## Preliminary Acceptance – Punchlist from DPW Stormwater

Project Name:	Liberty Tree Academy Filing 2
EDARP Filing Number(s):	PPR-20-018
ESQCP Number:	ESQ1941
Attendees:	DPW SW: Joshua Augustenborg, Ben Jones, and Christina Prete DPW Planning: Brad Walters and David Parkerson Permit Holder: Jesse Schuckman
Date of Walk-Thru:	January 17, 2023
Walk-Thru Number:	1

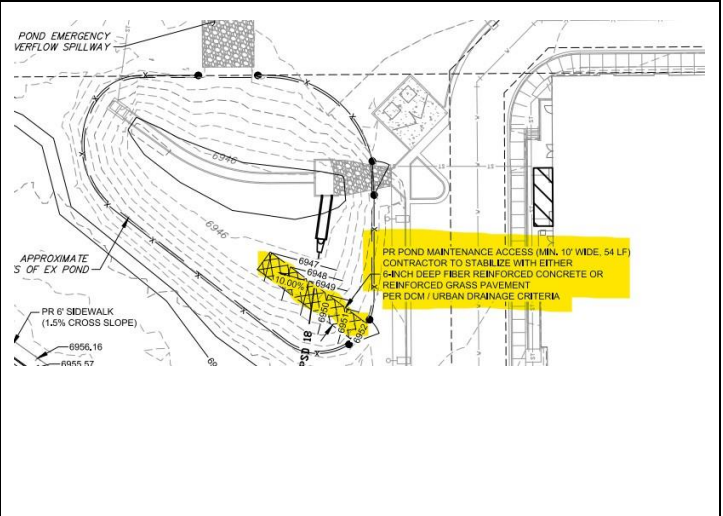
Photo 1: PR Pond perimeter chain link fence (install between top of existing pond slope and existing trees) Verify in As-Builds, Missing fence in field.

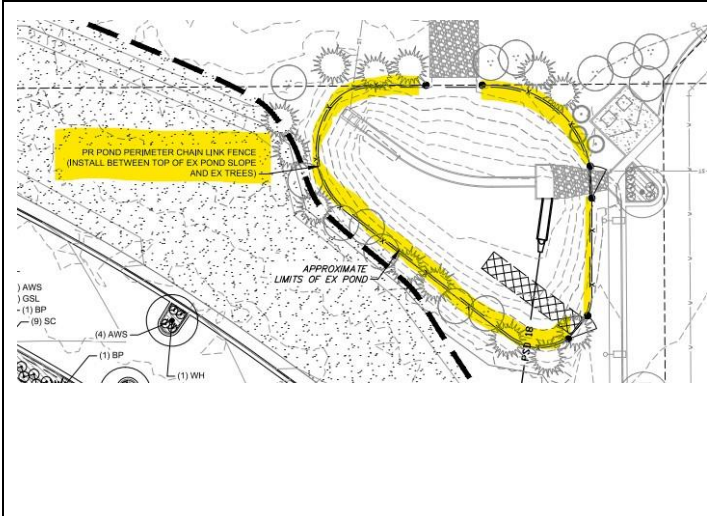
Photo 2: PR Pond maintenance access (min 10' wide, 54 LF) Stabilize with 6" deep fiber reinforced concrete or reinforced grass pavement pe UDC manual.
